Planning & Zoning Commission Hearing: November 17, 2022

**PDP210019, The Savoy**

**Summary of Request**

Staff recommends approval of one Modification of Standard and the Project Development Plan, with conditions.

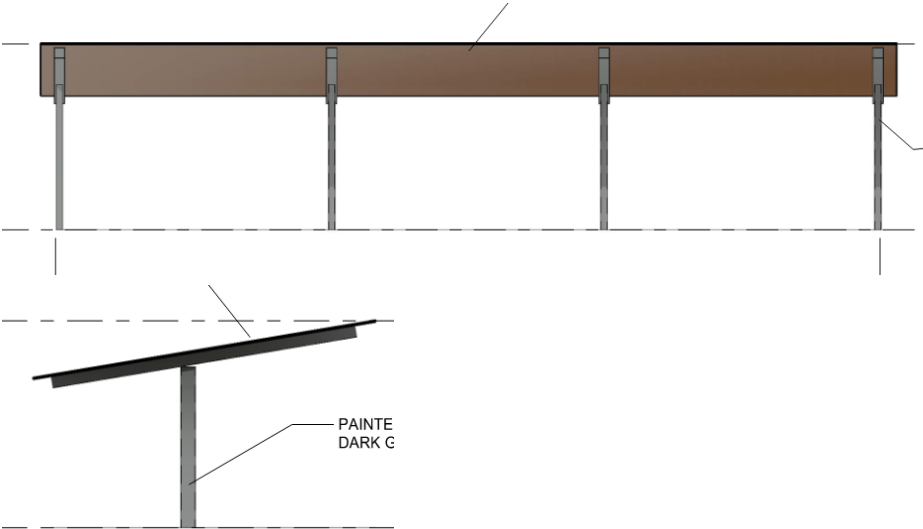
- If a street was constructed it would effectively reduce the block size into two 3.73-acre blocks that would not provide any greater level of pedestrian walkability than what is proposed. Further, the internal street would be lined by parking and not buildings which would require additional considerations regarding building frontage standards.
- The framework of streets has been previously set by surrounding development. None of the three surrounding developments have local streets that could extend into the site to provide greater connectivity to the surrounding neighborhood (see image below).
